STATE OF HAWAII
DEPARTMENT OF TRANSPORTATION
HIGHWAYS DIVISION
KEEHI INTERCHANGE
FIELD TESTING PROGRAM
PILE INSTRUMENTATION
PILE 5
INTERSTATE ROUTE H-1
PROJECT NO. I-H-1(85)
SCALE: AS SHOWN DATE: 2/21/70
SHEET No. 10 OF 35 SHEETS

STATE OF HAWAII
DEPARTMENT OF TRANSPORTATION
HIGHWAYS DIVISION
KEEHI INTERCHANGE
FIELD TESTING PROGRAM

PILE INSTRUMENTATION PILE 5

CONTRACT CHANGE ORDER NO. 8

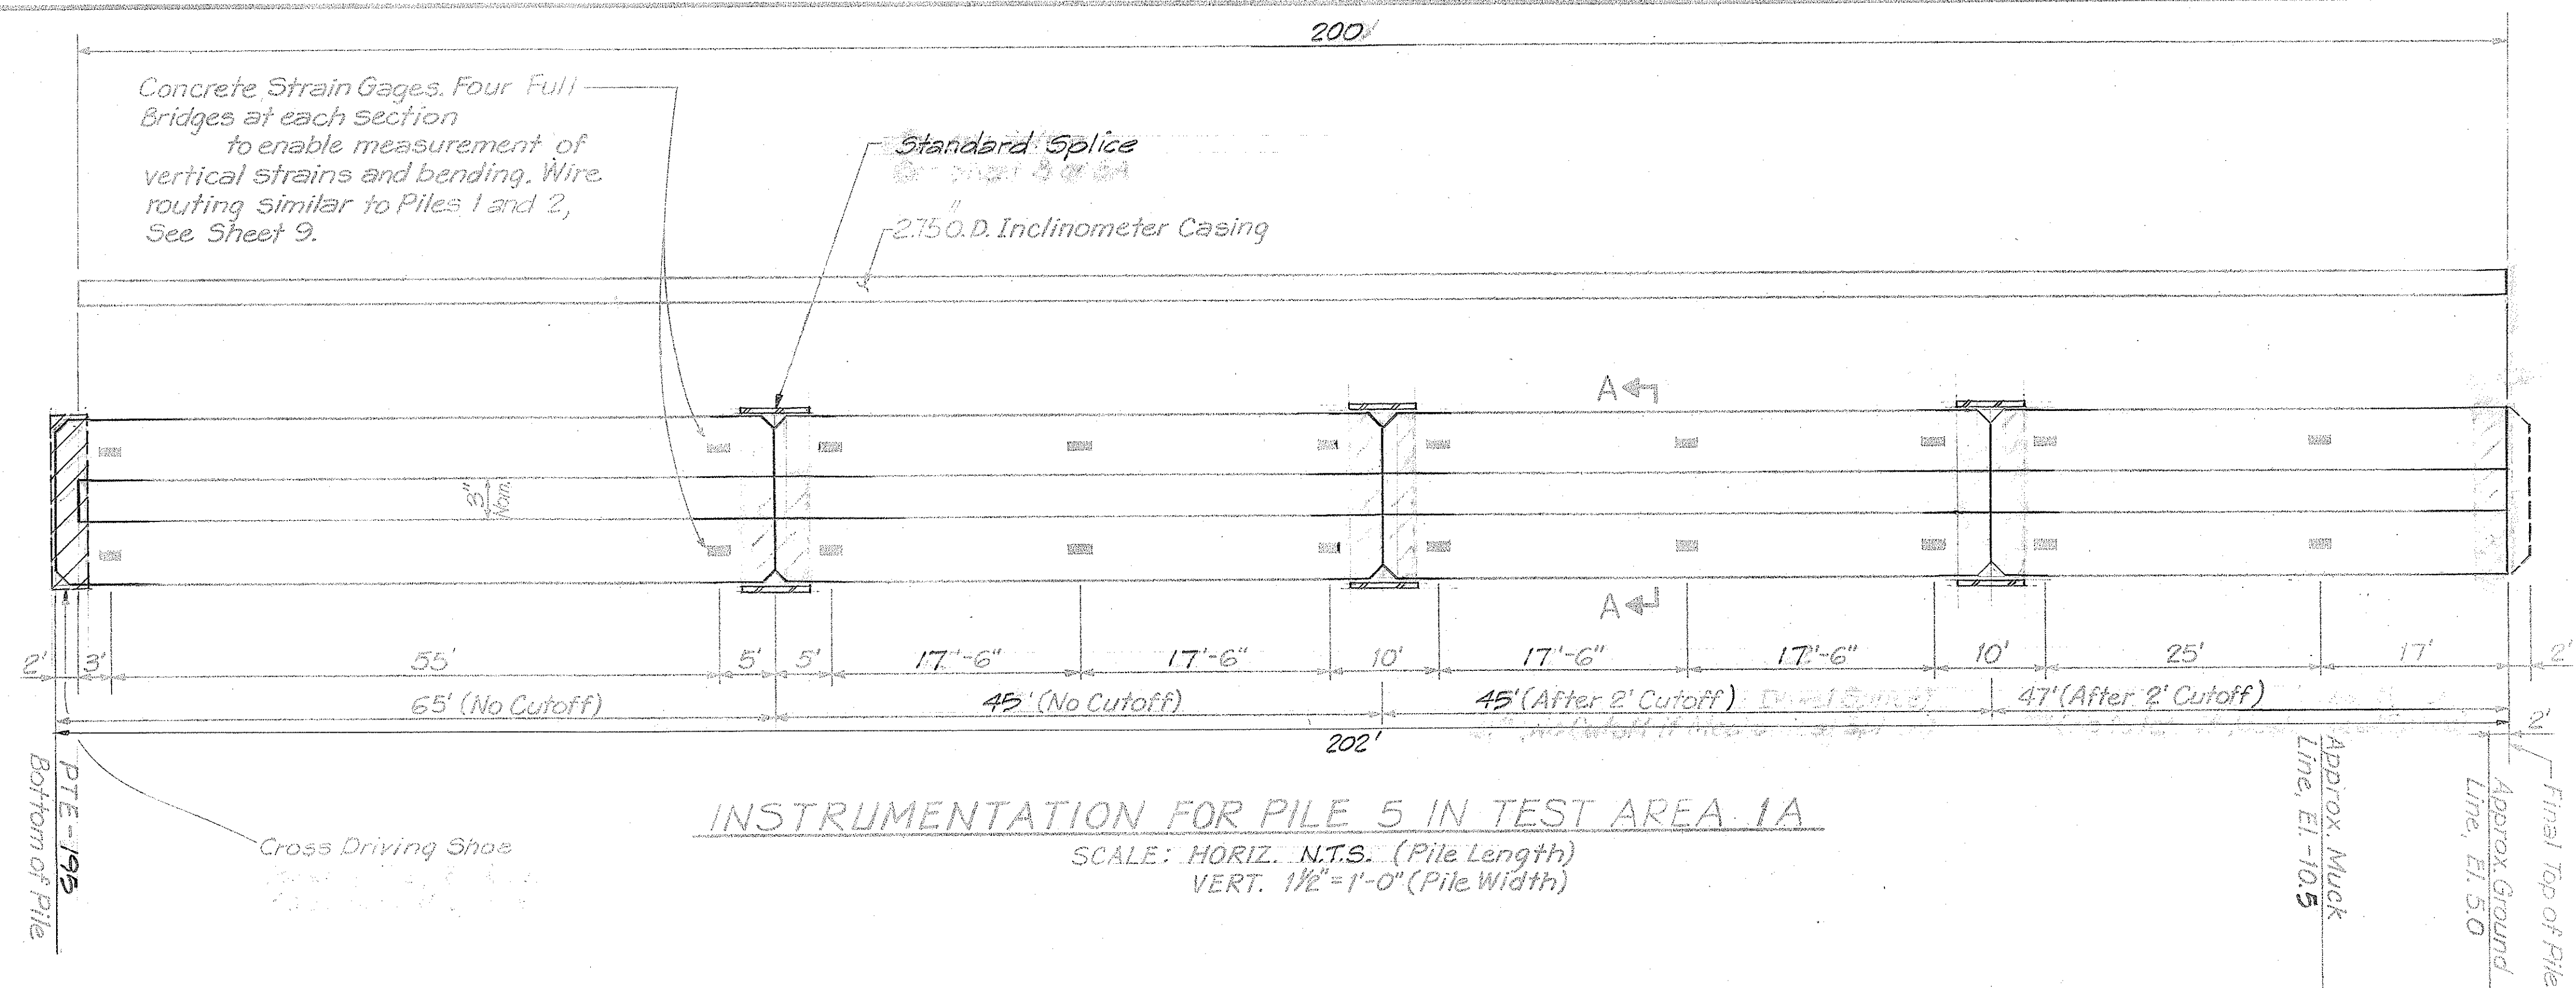
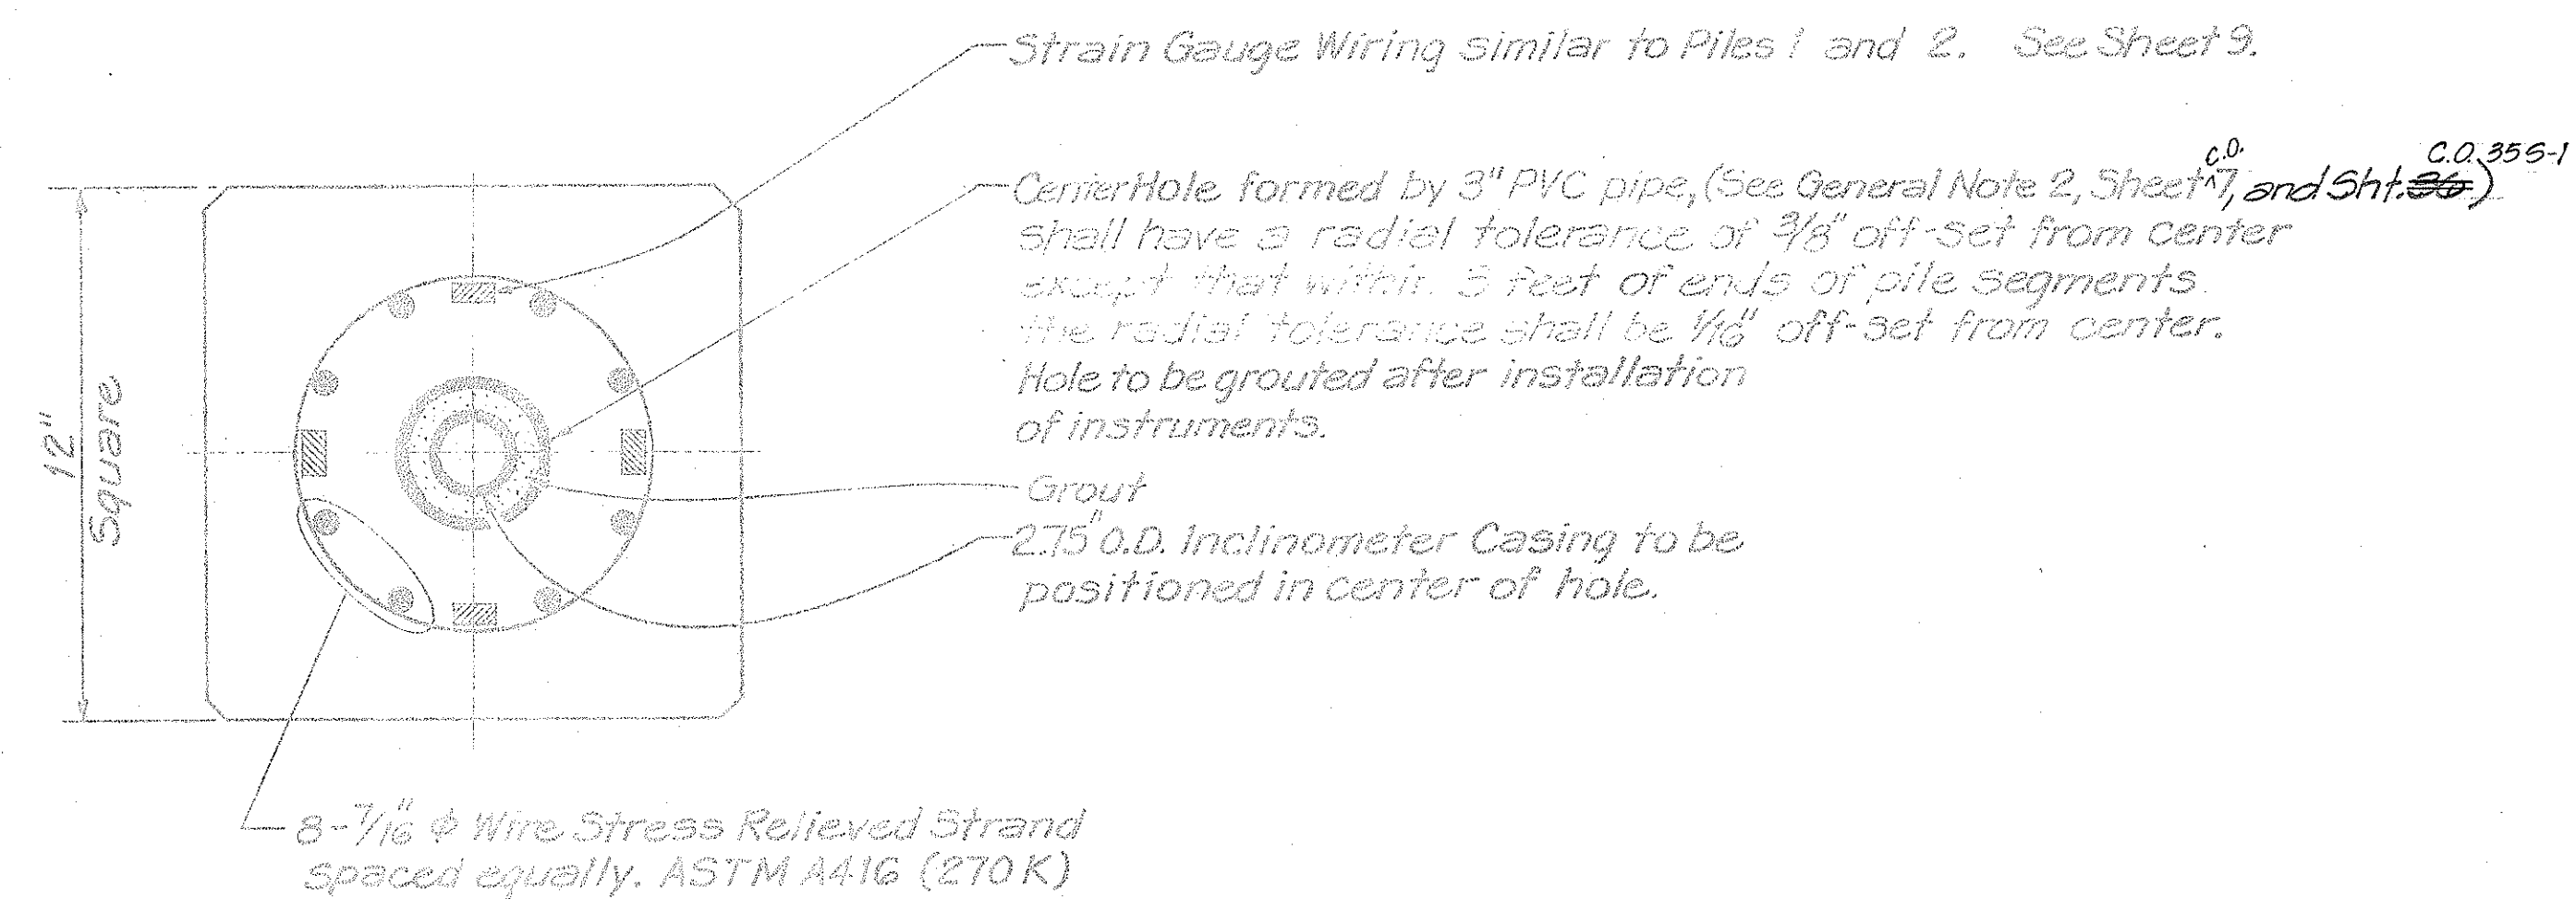
3/1/77	Pile length reduced and type of splice changed. Steel Sleeve installed deeper.
Date	Revision
